RE: **Lot 4A Block 9 Unit 18, S.A.D. 228**
Volcano Cliffs Subdivision
7904 Aguila NW
Grading and Drainage Plan
Engineers Stamp Date; 6-19-17 (D10D00I4)
Pad Certification Date; 9/18/17

Based upon the information provided in your submittal received 10/2/17, this plan cannot be approved for pad certification until the following comments are addressed.

BURK - GRADING & DRAINAGE PLAN

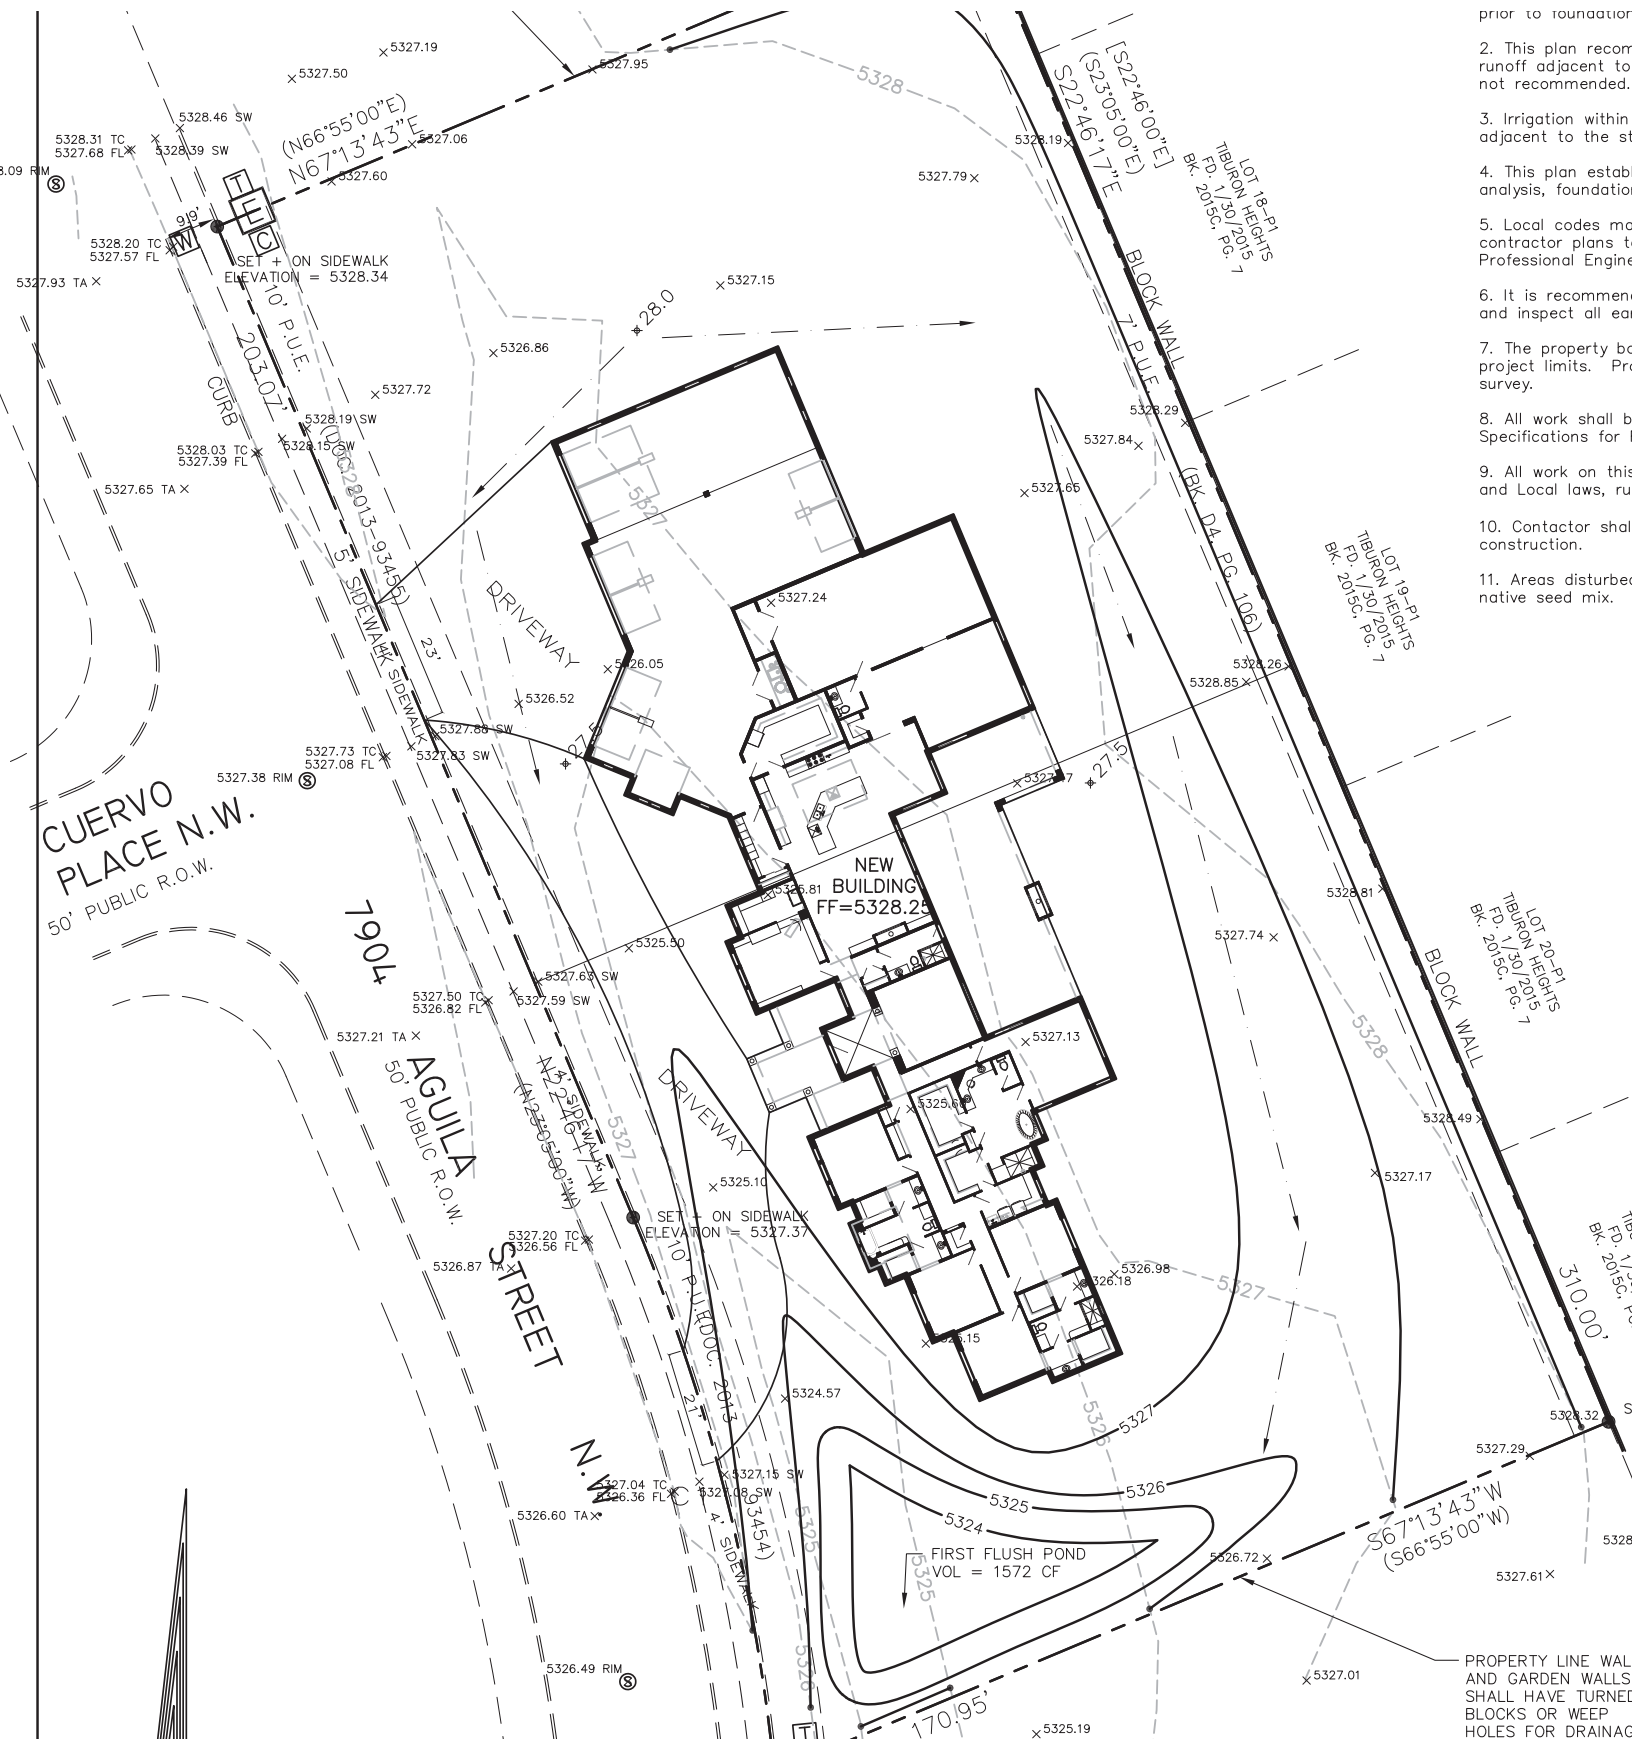
- Correct the Pad Certification language, and the discrepancies between the finished floor benchmark and the average elevation of the building pad.
- Define the finished floor benchmark.
